Staff Report for PLCUP-2603-0007

Application Type: Concurrent Use Permit

Location of Subject: 1712 W 3rd St

The applicant is seeking a concurrent use permit for construction of a replacement deck and stairs to provide code compliant access to residential units.

CONCURRENT USE DETAIL

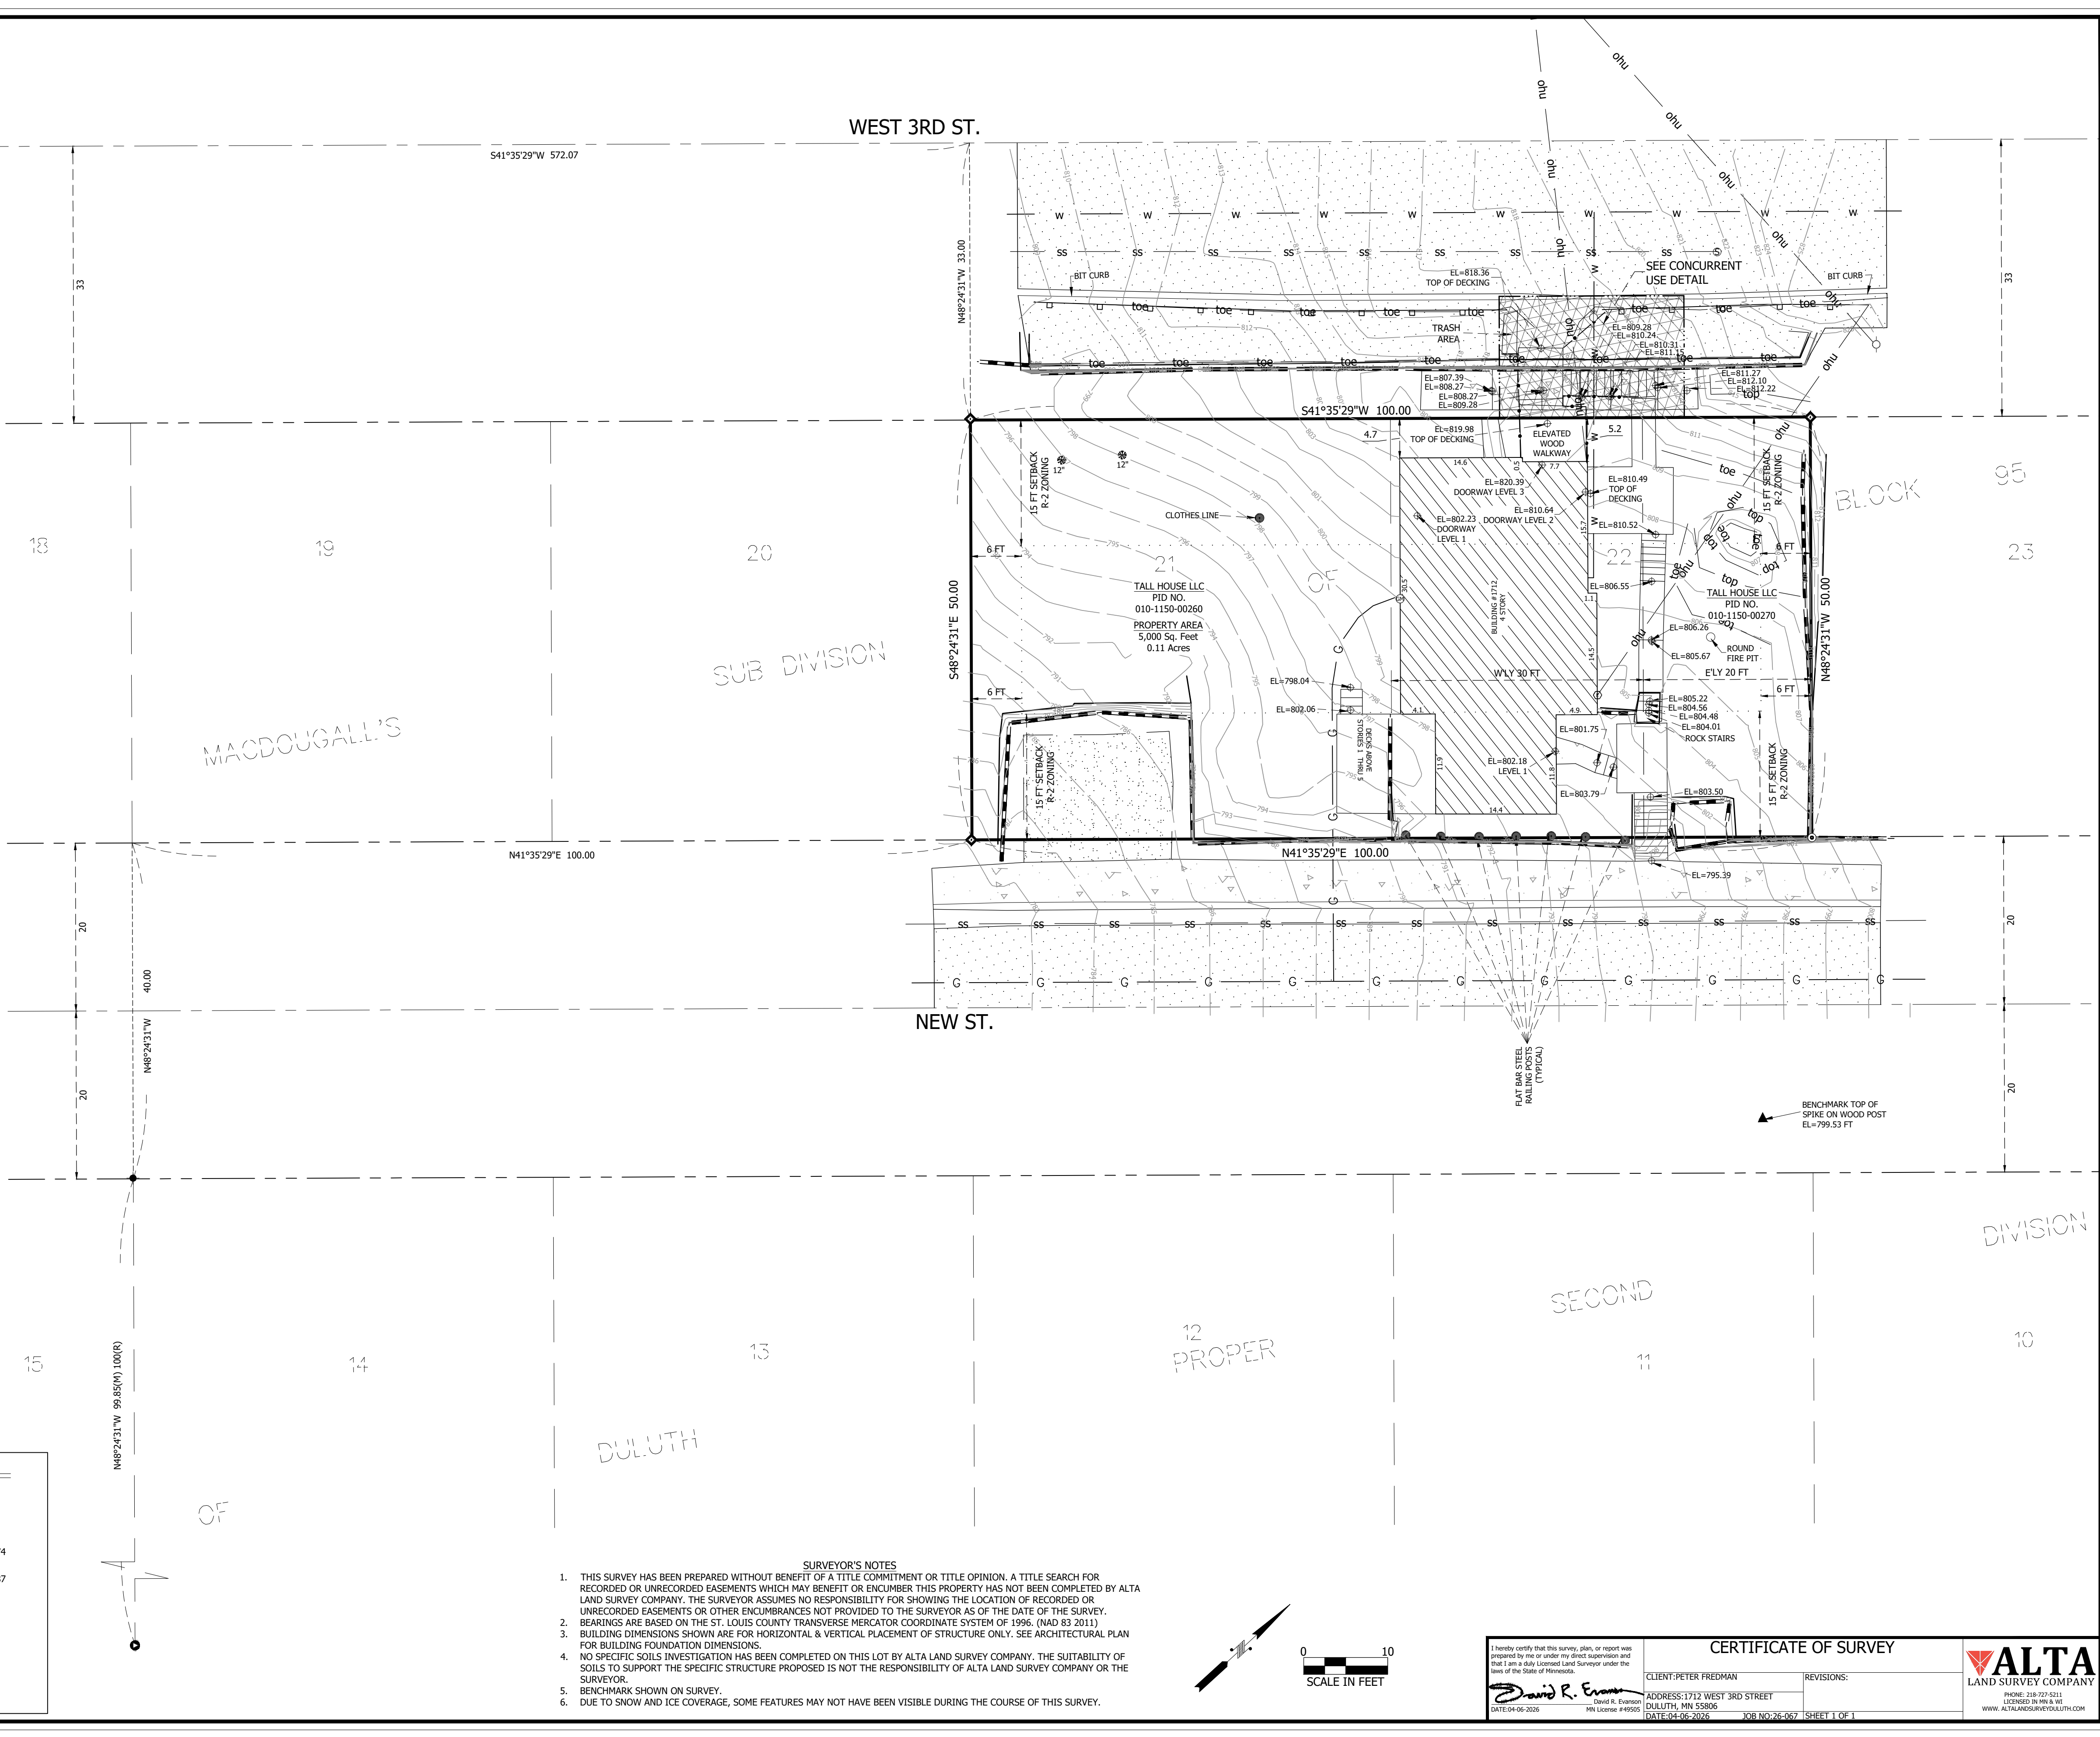
6. One comment was received from Engineering, asking whether a handrail is proposed to extend into the sidewalk. Design elements will be reviewed during the building permit review. No other City, agency, or public comments were received.

Ok, I see the survey, but it references the concurrent use drawing. All I want to know is there going to be railing extended into the sidewalk or not.
